Metropolitan Development Commission Regional Center Hearing Examiner (December 15, 2022) Meeting Agenda

STAFF REPORT

Case Number	2022-REG-067
Address (approx.)	675 East Washington Street
Location	Center Township, Council District # 16
Petitioner	Global Indy III, LLC, by Jamilah Mintze
Zoning	I-3 (RC)
Request	Regional Center Approval to provide for a 10,000-square-foot building addition to an existing 85,000-square-foot building and minor façade improvements. Existing windows, glass block, brick veneer and main entry would remain.

Site plan

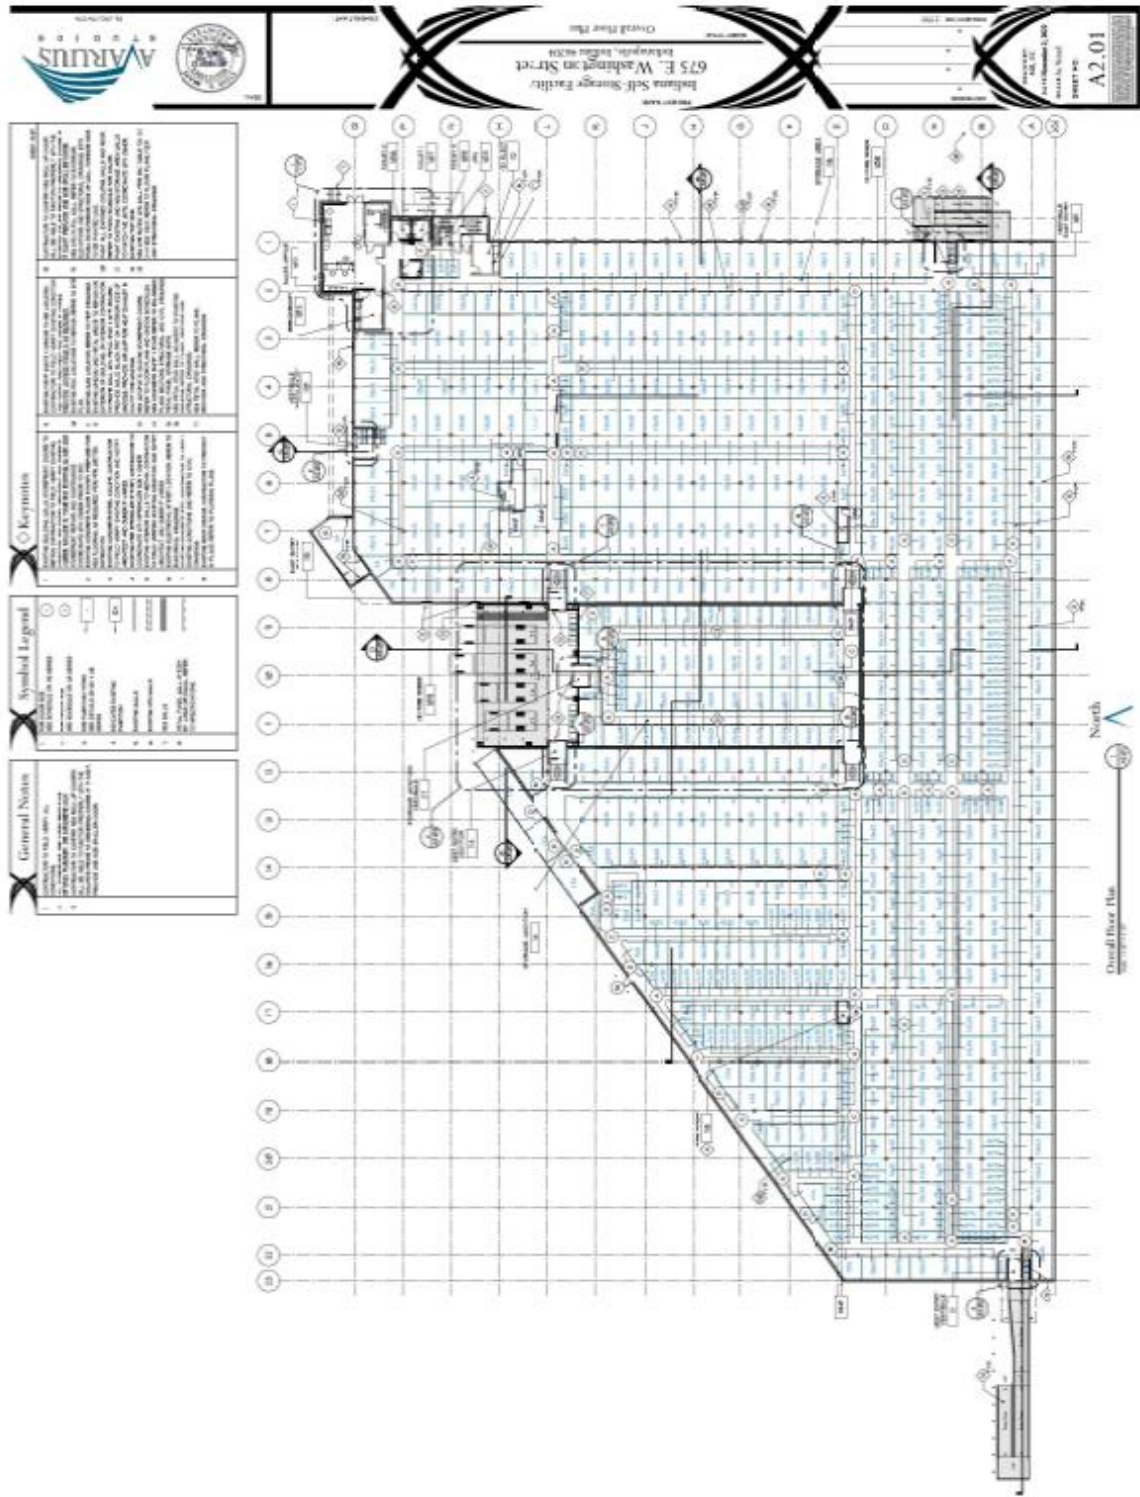
3. A landscape plan was not submitted with this request. Staff proposes that new landscaping be added along College Avenue and at the corner of College Avenue and Washington Street. A landscape plan shall be submitted and subject to planning staff review and approval, prior to the issuance of an Improvement Location Permit. These Guidelines shall be reviewed in formulating the landscape plan: US 1.3.2, SC 3.4.2, CA 4.4.3, CA 4.6.1, CA 4.6.2, and CA 4.6.4.

Elevations

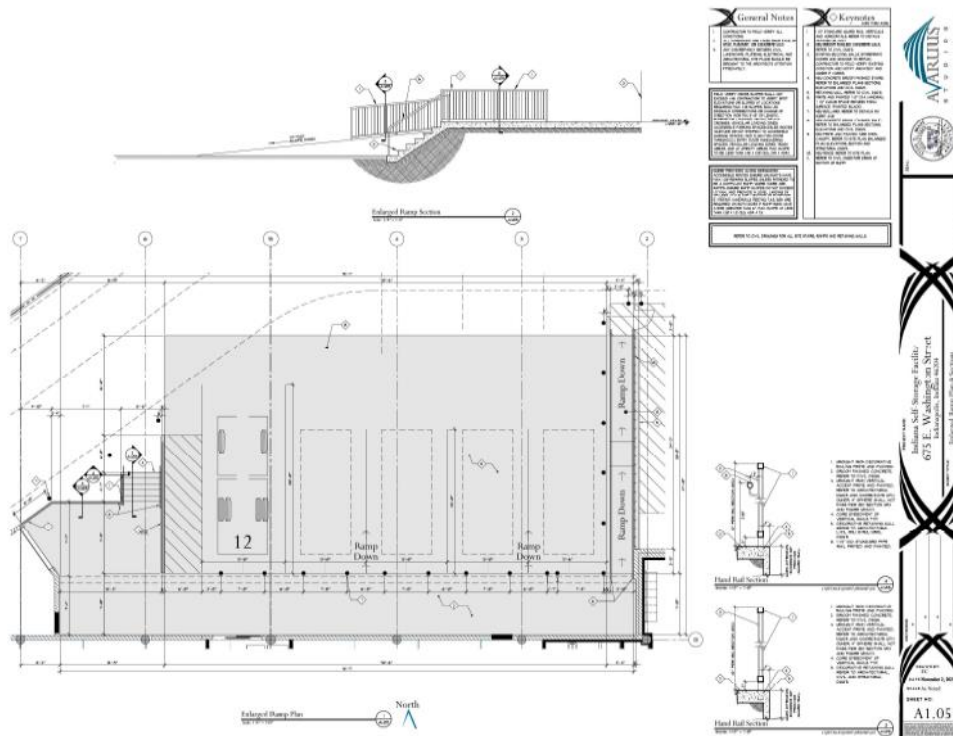
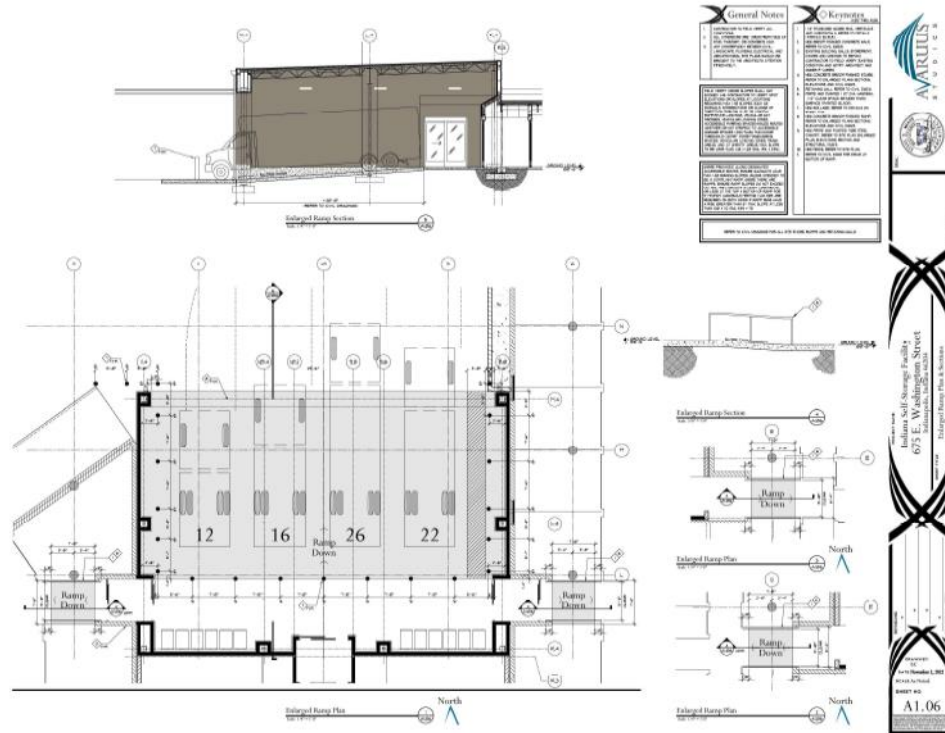
2. The following Guidelines relate to site buffers and building character, including paint colors: US 1.2.1, US 1.2.3, SC 2.1.1, CA 1.2.4, CA 2.1.1, CA 2.1.2, CA 2.2.1, CA 2.2.2, CA 2.3.1, and CA 2.3.4. The existing loading dock on the north side of the building would be visible from College Avenue, especially when trucks are being loaded and unloaded. Staff proposes that a masonry wall be constructed to shield the loading area from view of the public way and that this wall shall be tall enough to shield a typical rental truck. Additionally, the chosen paint color is too bright and should be toned down. Staff proposes that the color of the upper-most brick color on the two-story portion of the building, be used as a guide to finalize a paint color. This paint should also not cover the entire building along the public way. Staff has no issues with using the bright orange color for awnings or canopies. A photo of the brick to use as a guide is below. A revised elevation plan noting the above recommendations shall be submitted and

5. Guidelines CA 2.1.3, CA 2.1.4 and CA 2.4.1 require windows for the commercial use to be a minimum of 59% visible light transmitted through the window along grade level. No new windows are proposed at grade level for this existing building. The building is separated from the public way by an existing paved area. Staff would accept that to meet these Guidelines would require a building addition near the public way, which is not proposed.

subject to planning staff review and approval, prior to the issuance of an Improvement Location Permit.
